Subject: Section 92 Request - WAT60444605 Queen Street, Auckland Central 1010

# Watercare Services Limited Groundwater and Settlement Monitoring and Contingency Plan

Queen Street Wastewater Diversion Programme: Part 3 - Part 6 Link Project

W-SL001.04

Figure 4-1: Schematic diagram showing monitoring sites and groundwater alert levels (not to scale).

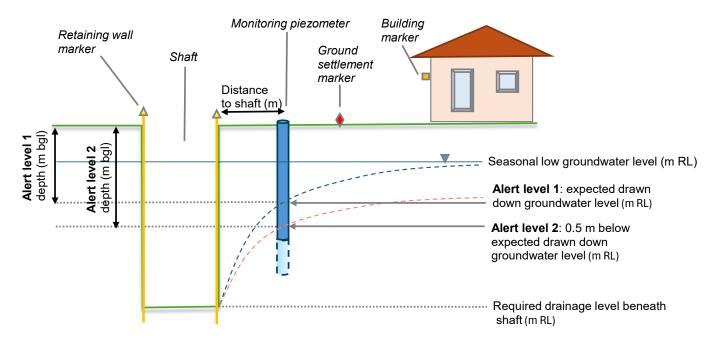
- 1. Table 5 in the draft GSMCP is not clear Alert Level No. 1 and Alert Level No. 2 are not given. Please provide a sketch of the standpipe piezometer showing the proposed excavation level, the proposed Alert Levels No.s 1 and 2 in both m bgl and mRL and updated Table 5 accordingly.

The first alert level will be set as the lowest groundwater level considering seasonal variation, plus a dewatering drawdown as per Table 5. The second alert level will be set as an additional 0.5 m of drawdown. A schematic diagram of monitoring sites and groundwater alert levels is shown in Figure 4-1.

Piezometer	Seasonal low groundwater level 2 (expected drawn down groundwater level) Alert level 2 (0.5 m below expected down groundwater level)		(expected drawn down		expected drawn
	Level	Level (m RL)	Depth (m bgl)	Level (m RL)	Depth (m bgl)
PZ24/03	13.75m RL 13.76m bgl	11.25	16.06	10.95	16.56
